## **ARCHITECTURAL ADVISORY COMMITTEE MEMORANDUM**

DATE: April 19, 2021 UNFINISHED BUSINESS

SUBJECT: REQUEST BY JAMIE CHISICK, ON BEHALF OF OC COAST, INC., FOR A MINOR ARCHITECTURAL APPLICATION TO ALTER THE EXTERIOR OF AN EXISTING CANNABIS FACILITY, HIGHTEND, LOCATED AT 3395 NORTH INDIAN CANYON DRIVE, SUITE A (APN: 669-452-063), ZONE C-M, SECTION 34 (CASE NO. 3.1292 MAA). (NK)

***Image 1.3 South Elevation***

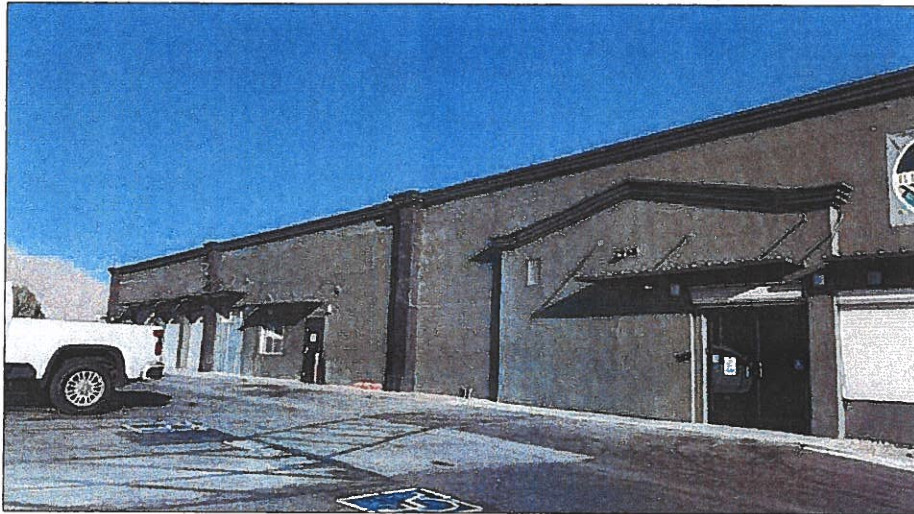
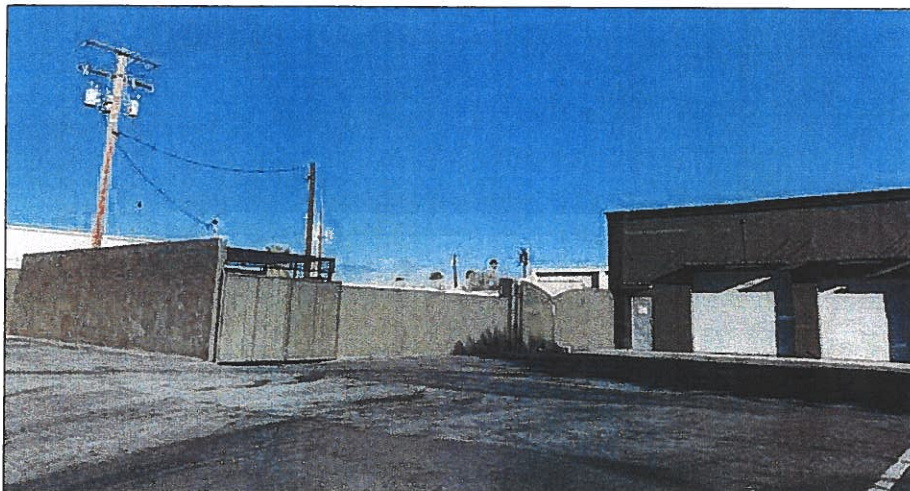
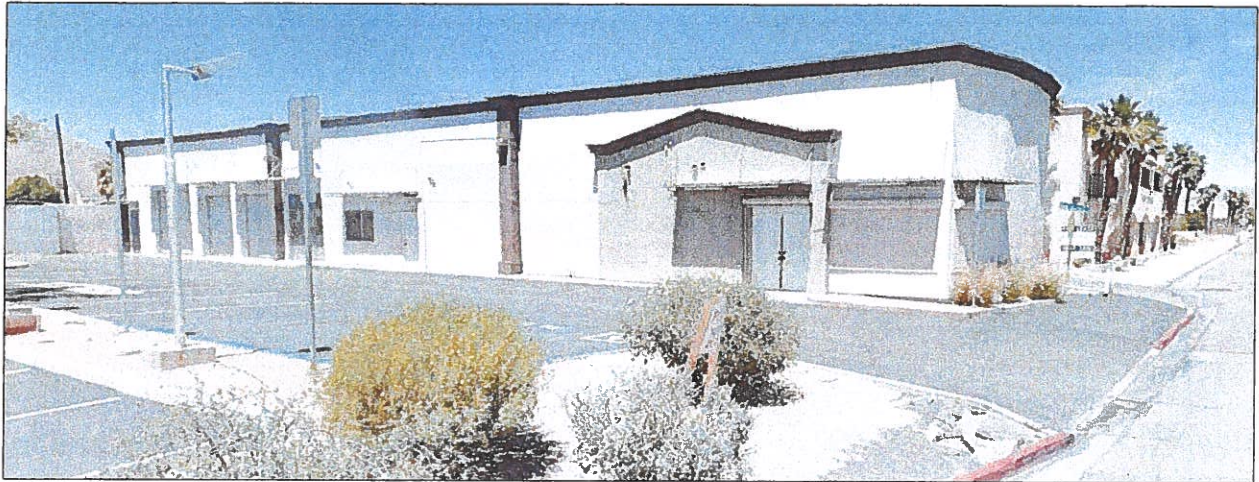
Member Poehlein stated that the entrance door shown in the site photograph appears solid while the elevation drawing shows a glass door. Chair Jakway stated that a glass door is installed at the site.

Member Lockyer questioned whether the roll-up doors still exist at the site or not, and Chair Jakway responded that the roll-up doors are currently in place.

Member Lockyer said the paint application on windows and doors needs to have more continuity. There are too many lights. He suggested instead of battery-powered lighting fixtures, hardwired lighting fixtures would be more appropriate. He thinks the new fixture needs to be more in keeping with the architecture/colors of the building. Member Lockyer thinks the existing landscaping detracts from building; and signage and lighting should be complimentary.

Member Walsh agrees with member Lockyer on roll-up doors being lighter as problematic. He thinks darker colors are acceptable, but the doors need to be addressed. He noted concern with existing landscaping, which could be utilized to make the property appear more attractive. He said that although it appears that the light fixtures are intended to define the entry, the application is not successful.

Member Thompson said that he's okay with the color but the doors should be darker to complement the building. He finds the repeated light fixtures as problematic, and the selected light fixtures are not appropriate.

Endurance Fin 19-Watt Graphite Outdoor Integrated LED Flood Light,  
3000K

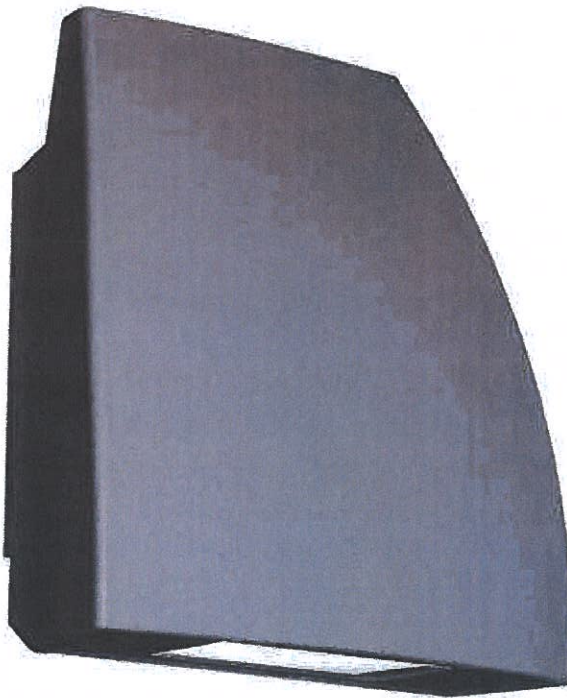
1. Use warmer light fixtures (3,000 kelvin).
2. Address the color of the roll-up doors and ensure that it is complementary with the rest of the paint scheme. This applies to other details around the façade on the south elevation, including the hinges and trims. The color should match or align with the trim color or something complementary.
3. Reduce the quantity of the light fixtures. Light fixtures need to conform to the zoning requirements, including the shielding requirement. Battery-powered light fixtures are discouraged.
4. Consider improving the condition of the landscape.
5. Future signage should complement the exterior light fixtures.

<b>Table 1.1 AAC Comments &amp; Proposed Changes</b>		
	<b>AAC Comments</b>	<b>Proposed Changes</b>
1	<i>Use warmer lighting fixtures (3k kelvin)</i>	Actual color temperature of 3000K is proposed (Attachment #4).
2	<i>Address the color of the roll-up doors and ensure they are complementary with the rest of the paint scheme. This applies to other details around the façade on the south elevation, including the hinges and trims. The color should match or align with the trim color or something complementary.</i>	Minor architectural accents such as the security roll-up shutters and garage doors of the adjacent tenant space will be painted in Dunn-Edwards Anchor Gray for consistency.
3	<i>Reduce the quantity of the light fixtures. Light fixtures need to conform to the zoning requirements, including the shielding requirement. Battery-powered light fixtures are discouraged.</i>	Unlike the previously proposed battery-powered light fixtures, the new fixtures will be hardwired. Quantity of the light fixtures will be reduced from 10 to 6 (4

Project 2018-05-03-395	SHEET No. <b>ELV-1</b>
date 12-17-2020	Scale 1/4" = 1'
Drawn by Leonardo Parra

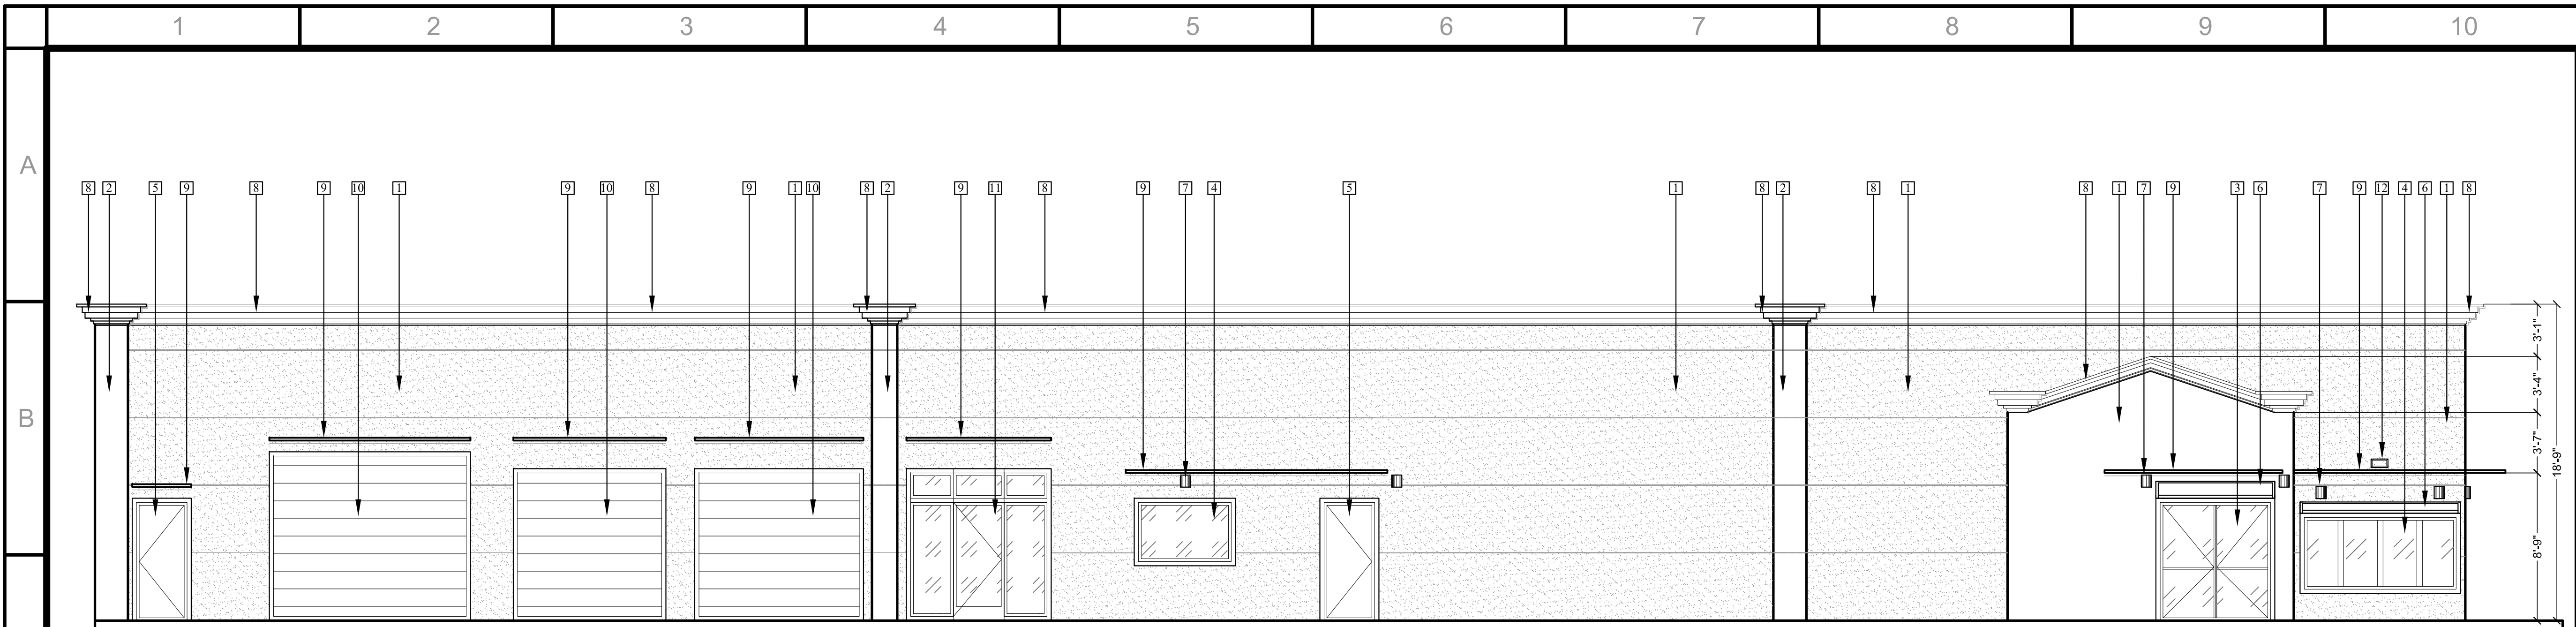
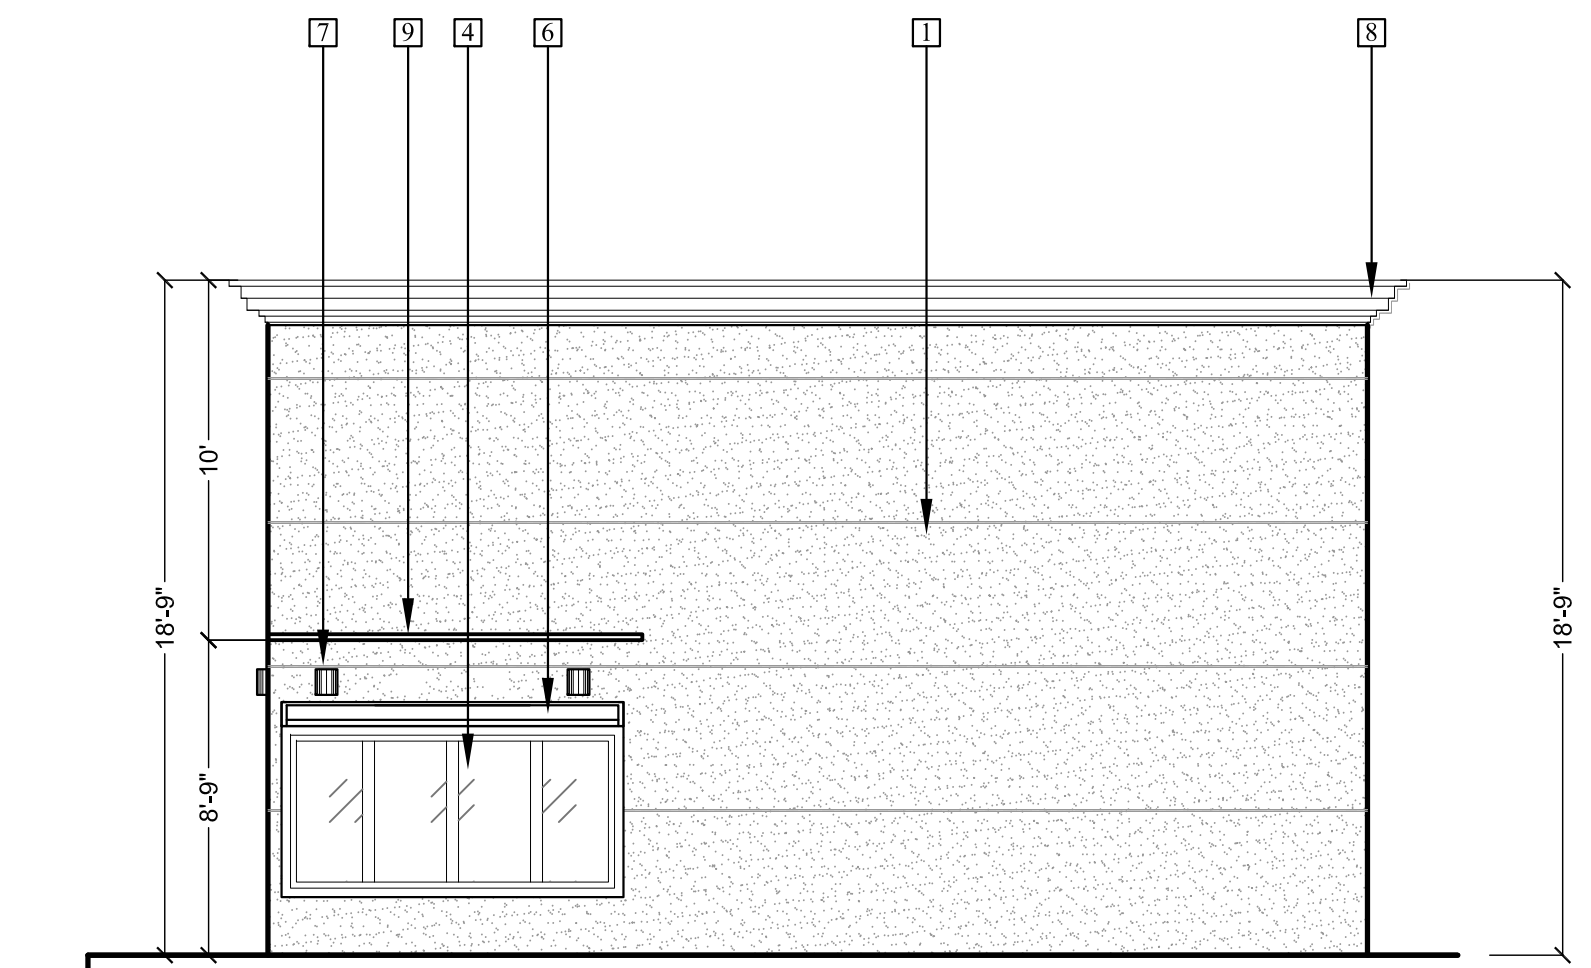
1. Two (2) horizontal wooden accents have been installed on the primary/south elevation of the building since the last AAC review (Attachment #3).
2. Flood light on the south elevation does not meet the outdoor lighting standard.

1. Remove any unpermitted architectural elements (e.g. battery-powered light fixtures, a flood light directed towards the banner on the south elevation, two horizontal wooden accents) within 14 days of the approval of this application by the City Council.
2. Applicant shall obtain a Building Permit for the installation of new light fixtures.

The submitted plan describes the windows on the south and east elevations “solid.” According to the most recent City policy pertaining to the treatment of cannabis facility storefront glazing areas, opaque storefront window/door treatment (e.g. tinted or blacked-out windows/doors) is no longer considered acceptable. An exception to this policy is the storefront window/door treatment of a cannabis lounge which is intended to conceal the visibility of smoking, inhalation, consumption, or ingestion of cannabis products from public view as required by the Zoning Code (Palm Springs Zoning Code Section 93.23.15.F.6.d). While a cannabis lounge is operated at the site, the consumption area is physically separated from the front reception area where the storefront windows and door are located. For these reasons, staff is recommending a condition of approval which requires the windows and door in the reception area to be transparent (Condition #3).

3. Street and parking-lot facing windows and door in the reception area shall not be opaque.
